APPLICATION NO.	FILING DATE	FIRST NAMED INVENTOR	ATTORNEY DOCKET NO.	CONFIRMATION NO.
10/581,705	06/05/2006	Hans Looser	5056.P0153US	4904
23474 7590 07/06/2009 FLYNN THIEL BOUTELL & TANIS, P.C. 2026 RAMBLING ROAD KALAMAZOO, MI 49008-1631				
EXAMINER CALABRESE, MICHAEL A				
ART UNIT 3637		PAPER NUMBER		
MAIL DATE 07/06/2009		DELIVERY MODE PAPER

Office Action Summary

DETAILED ACTION

FIG. 3
 Metz et al.
 US 6,834,840 B1

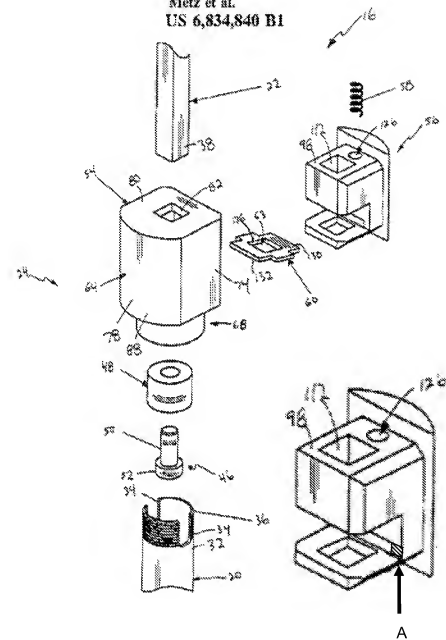
43. As for Claim 5, as best understood, Metz discloses the at least one brake body (130) is arranged laterally on the guide part (22) (See Figure 4) and the actuating means (56) includes at least one rib part (A; See marked up Figure 3 below), extending past the side of the at least one brake body (130) (rib part extends on the right side of the brake body 130 looking at Figure 3) on the guide part (22), such rib part (A) having a ramp face arrangement acting directly or indirectly on the brake body (130) (rib part acts on the brake body in a sloped relationship), such arrangement thrusting the at least one brake body (130) against the support part (22) on operation of the actuating means (56).

62. As for Claim 5, as best understood, Metz further teaches the at least one brake body (130) is arranged laterally on the guide part (22) (See Figure 4) and the actuating means (56) includes at least one rib part (A; See marked up Figure 3 above), extending past the side of the at least one brake body (130) (rib part extends on the right side of the brake body 130 looking at Figure 3) on the guide part (22), such rib part (A) having a ramp face arrangement acting directly or indirectly on the brake body (130) (rib part acts

on the brake body in a sloped relationship), such arrangement thrusting the at least one brake body (130) against the support part (22) on operation of the actuating means (56).
